Change Order No 4

To: R.E. Smith Construction Co. Project: Joplin Public Park (CDBG Mercy Park)

1. Description and Reason for Change (Attach Supplemental Sheets if Required)
   -Foundation and Removal

Joplin Public Park
Change Order ~~#3~~ #4 Descriptions

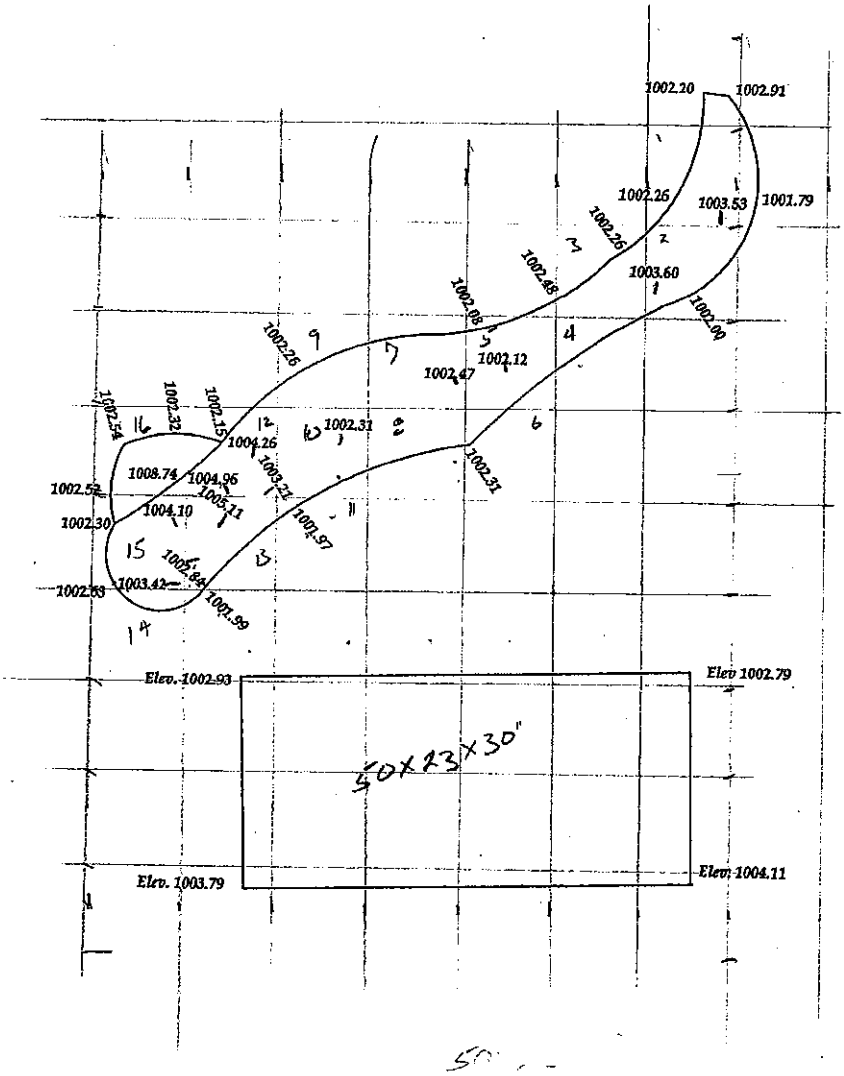
Description: Remove Conc foundation

Remove reinforced concrete foundationg
86' x 5' x 30" = 39.815 cy @ 300.00=$11,945
